Initial Project Review

Conditional Use Permit Major Amendment / Site Plan Review: PenMet Parks Community Recreation Center

Application Numbers: 906050 / 906052 / 906054 / 906861
Tax Parcel Numbers: 0221282036, 0221282009, 0221282044

FIGURE 18A.15.040-2

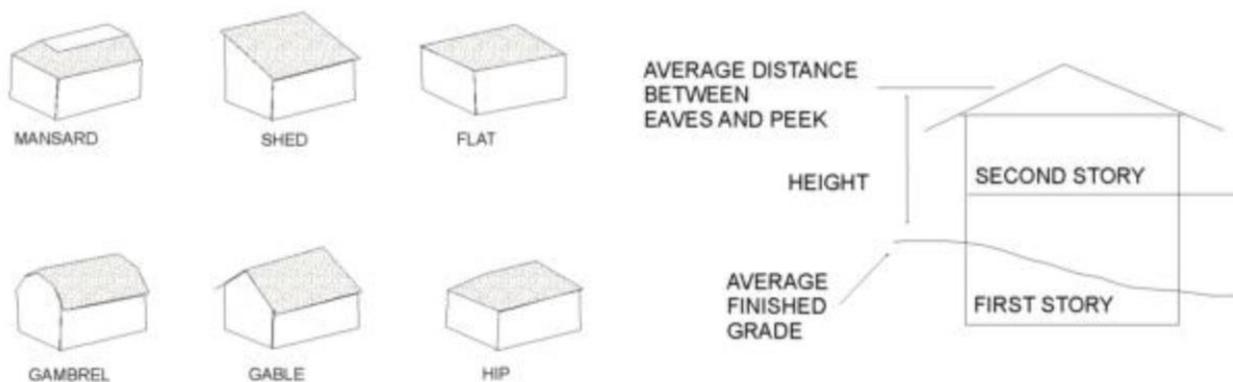
Staff Comment: The proposed building would be 84 feet tall. The Agent states that based on the definition of how the height is measured above (and the corresponding diagrams below), that the proposal comes close to meeting the height limitation.
